Land Configuration Design Basis - Preliminary

Rocky Flats Environmental Technology Site

PREAMBLE TO LAND CONFIGURATION DESIGN BASIS - PRELIMINARY

The first section contains the Work Plan revised per DOE/FWS and regulatory agency comments. Those comments along with the KH responses are also included. Some of these issued raised by the comments cannot be resolved until additional information is available and these are noted as being deferred.

Figure B-04

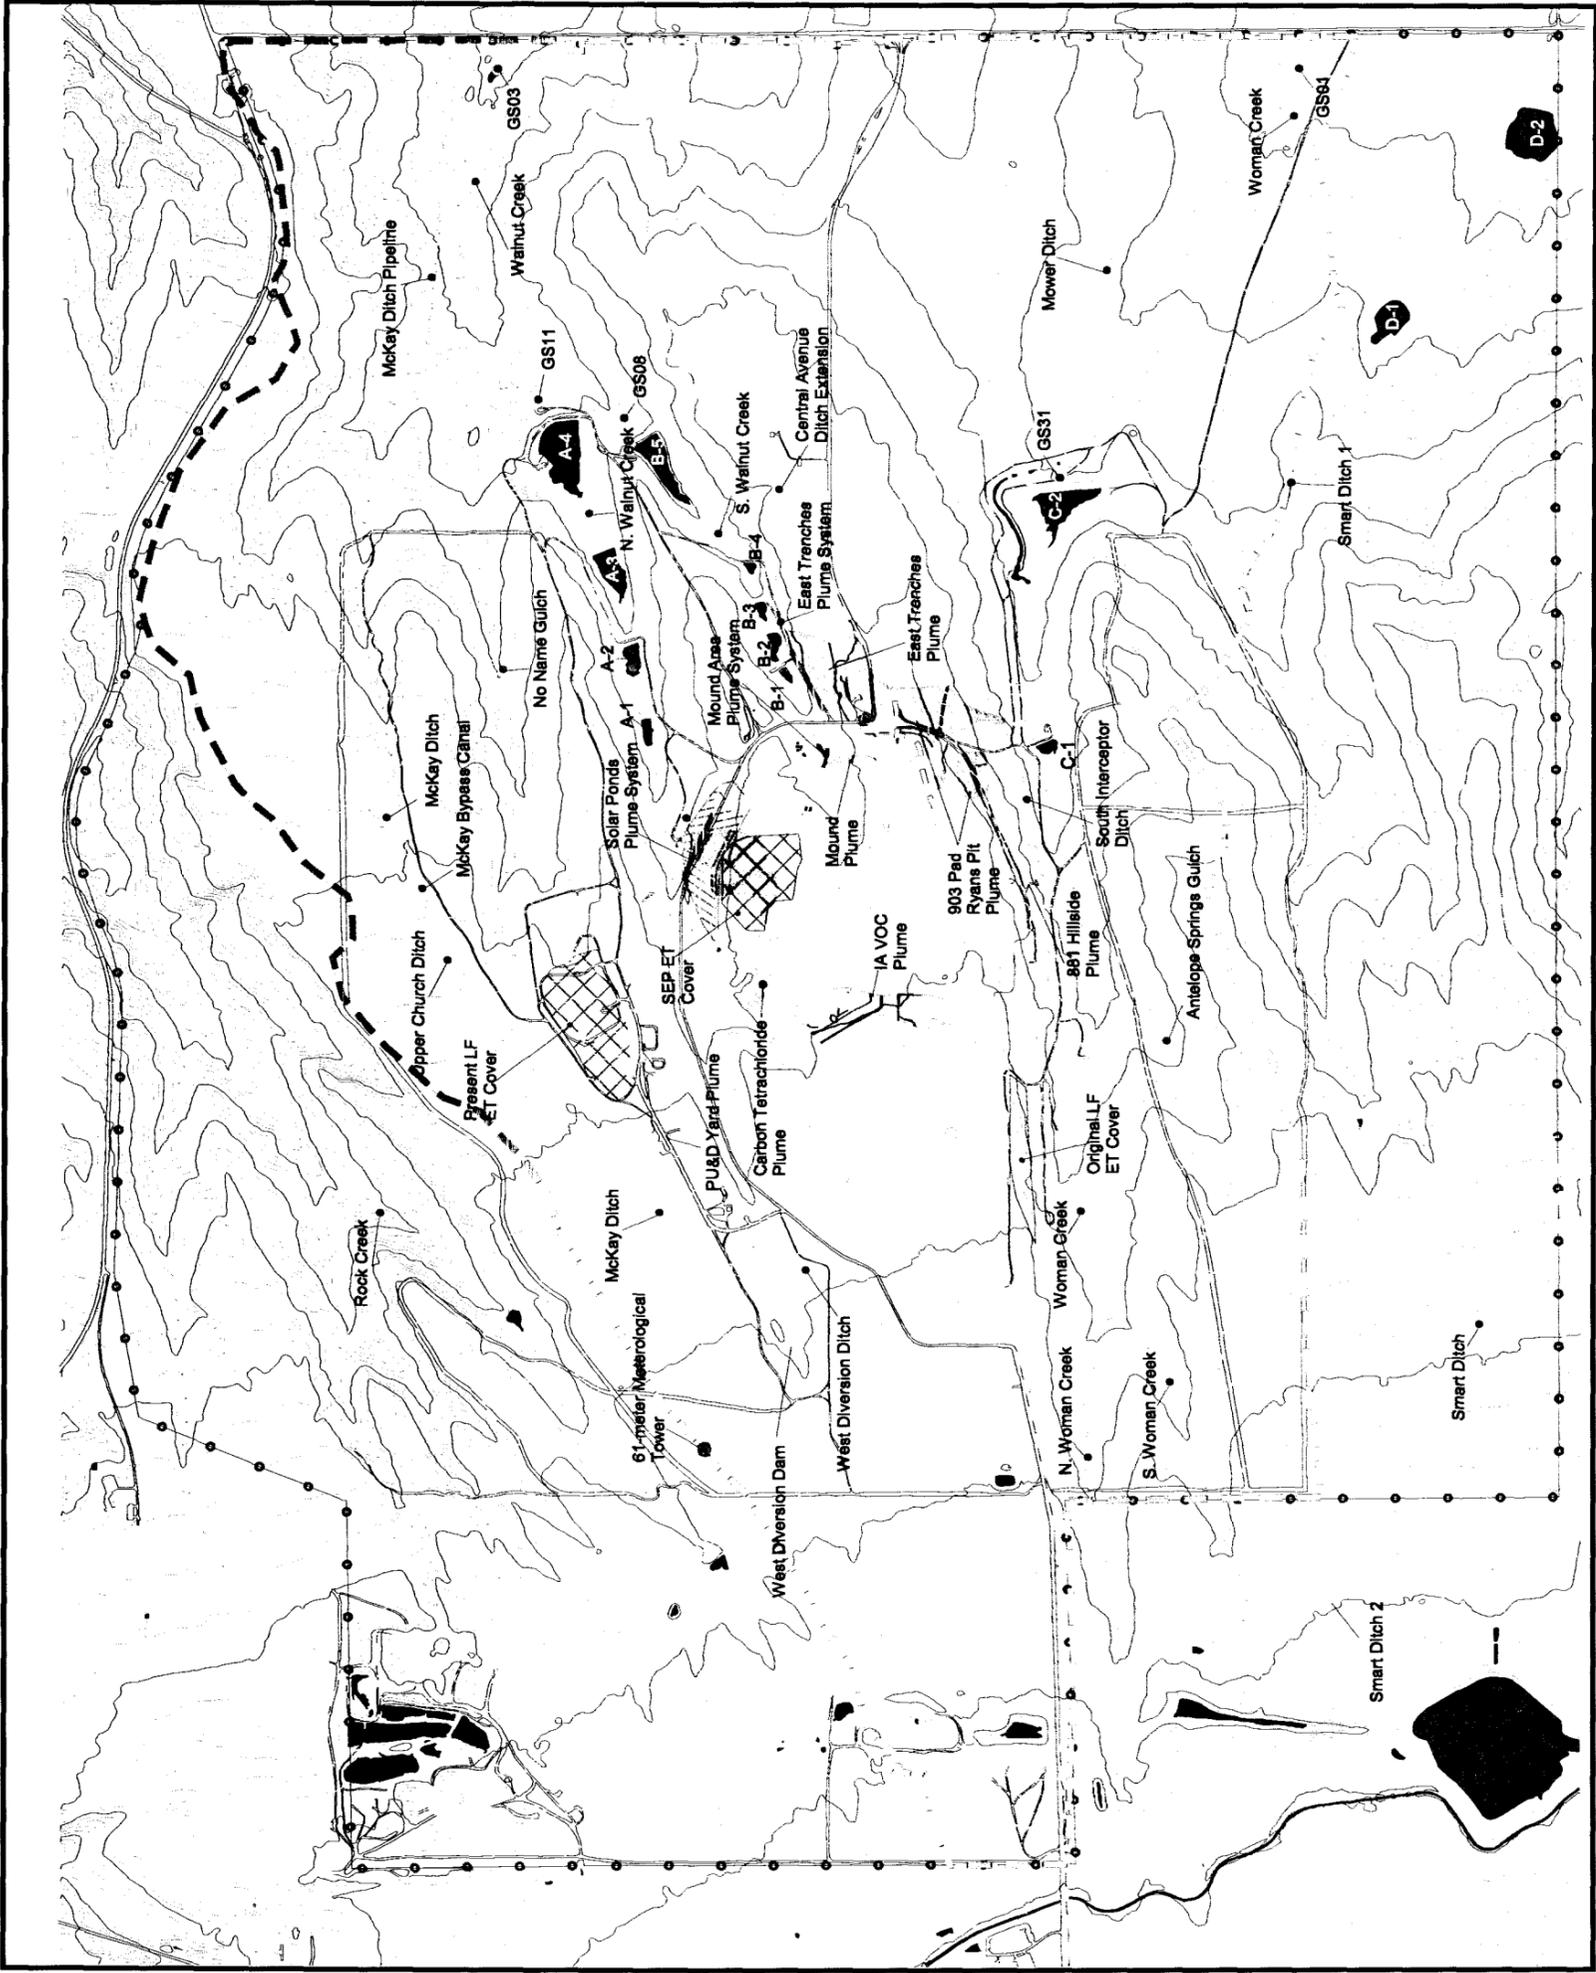
Comment 45: Appendix B, Section 2.5.6.1, 881 Hillside French Drain - Even if concentrations of organic chemicals are below surface water standards, any discharge of groundwater to the SID with detectable organics will be considered to be a "point source discharge of pollutants". These drains and others developed for remediation need to be included in Figure B-04.

Figure B-13
Wetland Location Map
Based on 1994 Delineations

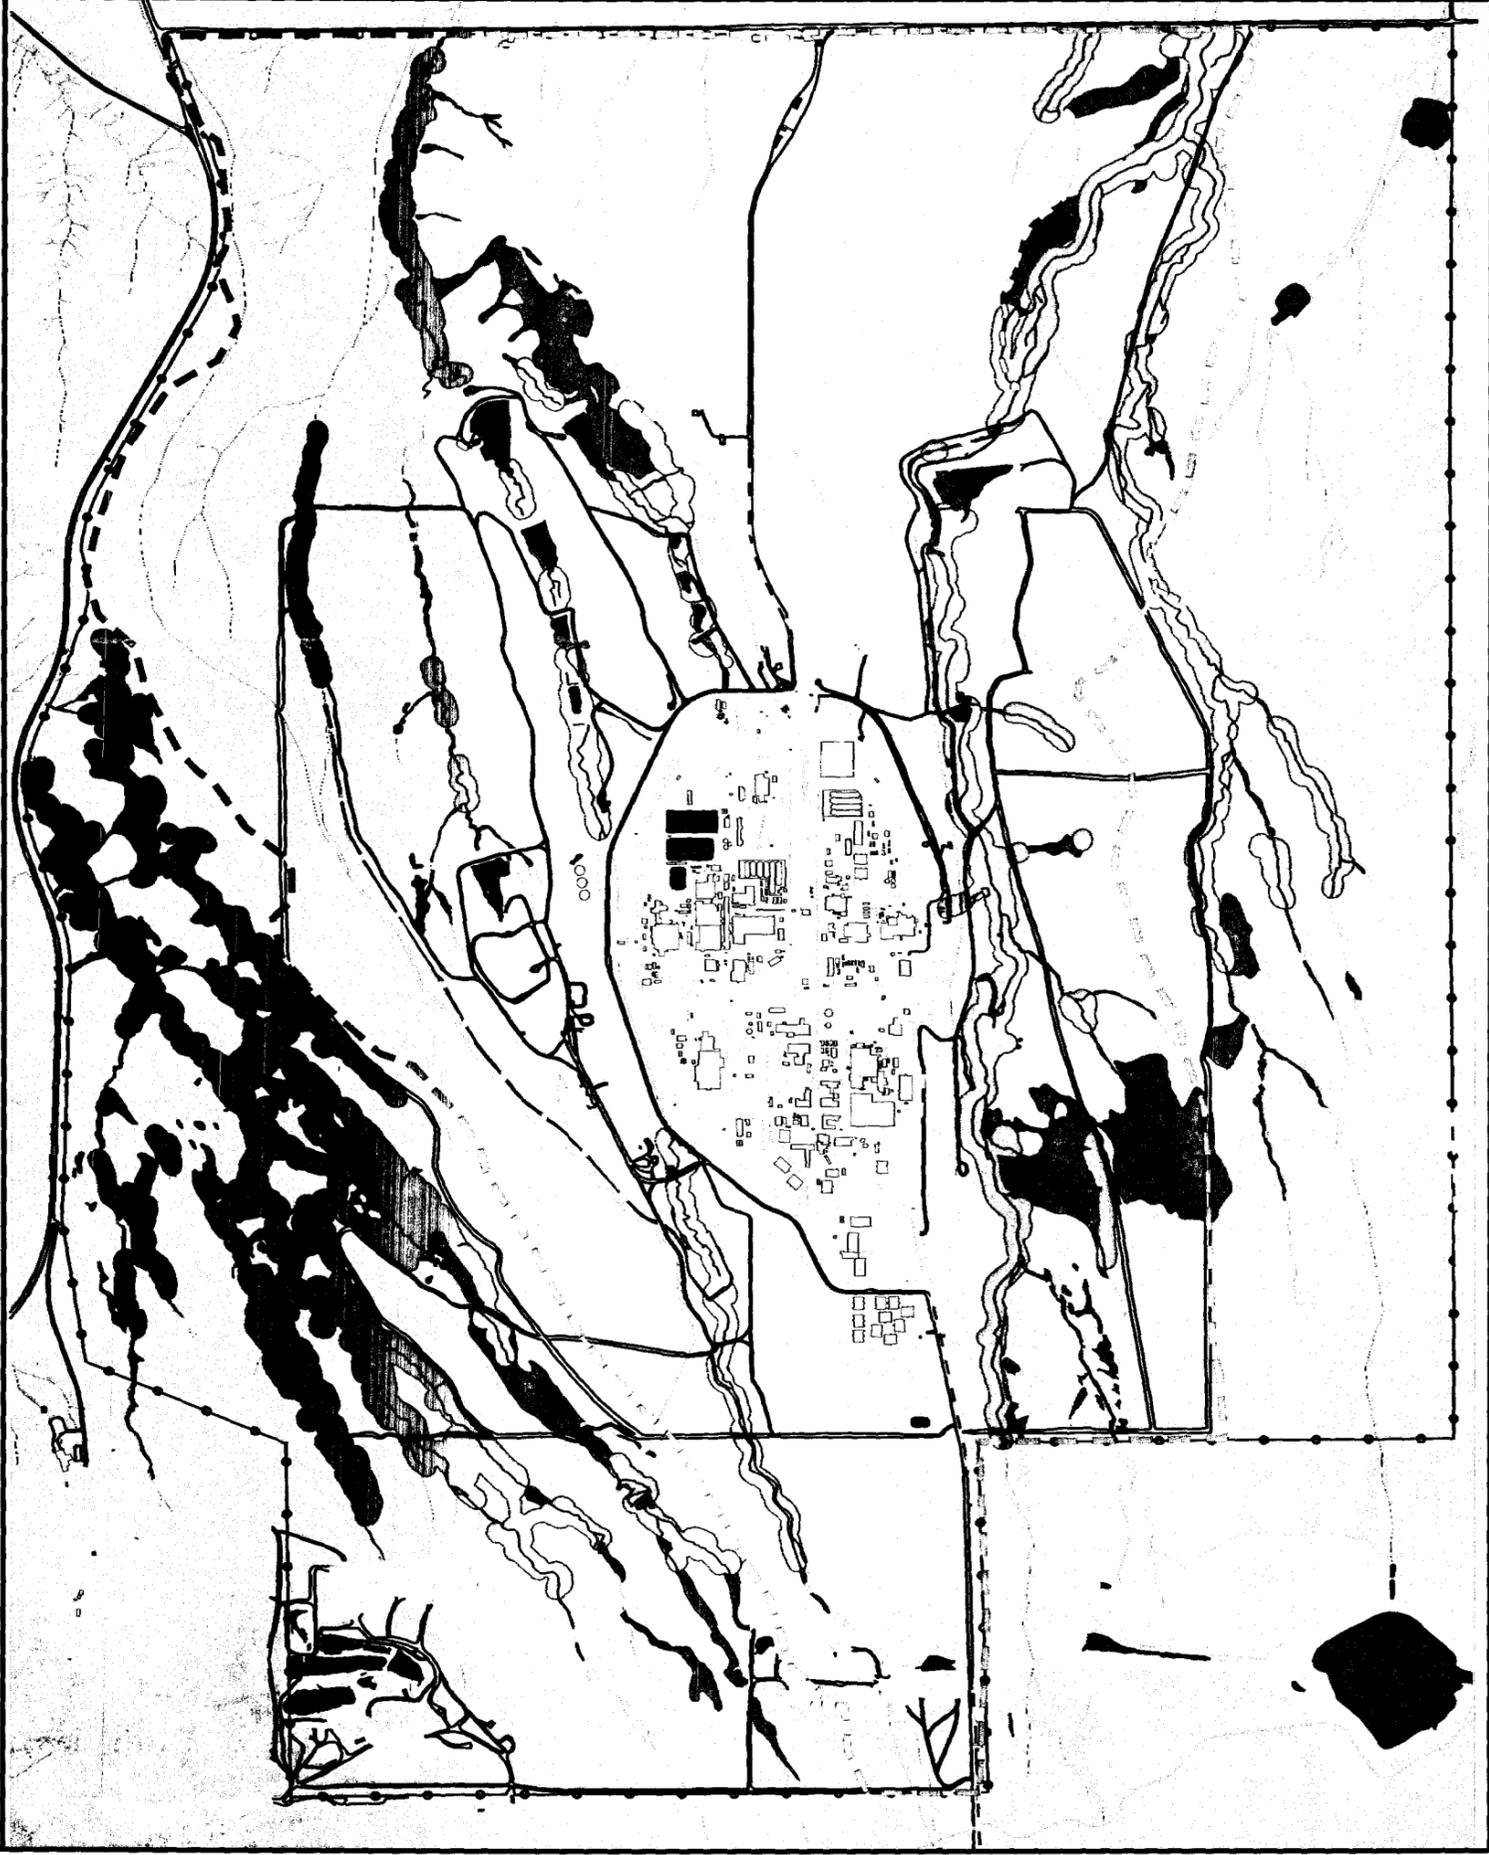
Comment 84: Figures B-11 and B-12 cite different wetland acreages of 186 and 192.1 acres. There is a third different wetland acreage cited in the document. Which is the correct wetland acreage on Site? There is a reason why the acreage is different but it is not immediately clear to the reader. Please clarify for reader not familiar with the Site.
